SERVICE BULLETIN

BULLETIN NO_	WSB0338
SECTION	(08) Axie
MODEL(S)	L80F/L100/L100F/L120D/
1	L4120D/L130B/L4130

Subject: Wheel Wedges (Dual Drive Wheels)

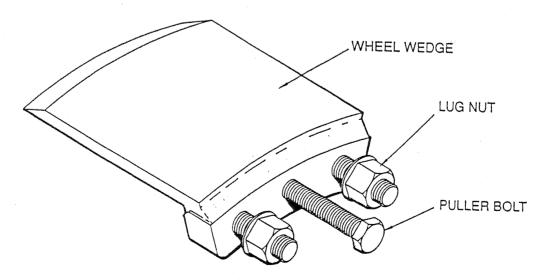
For easier removal of wheel wedges on all dual drive wheel applications, a puller hole has been added to each wedge.

To remove the wedges, simply loosen the lug nuts. **Do Not** remove the lug nuts at this time, as this prevents the wedge from possibly breaking loose, falling off and causing personal injury. Insert a puller bolt into each wedge puller bolt hole, and force each wedge free.

Current production machines will have this updated wedge, and any new wedges ordered through your WAGNER dealer parts department should be the new type with a puller hole.

If you choose to rework your existing wedges, please contact your local dealer for proper drilling and tapping instructions.
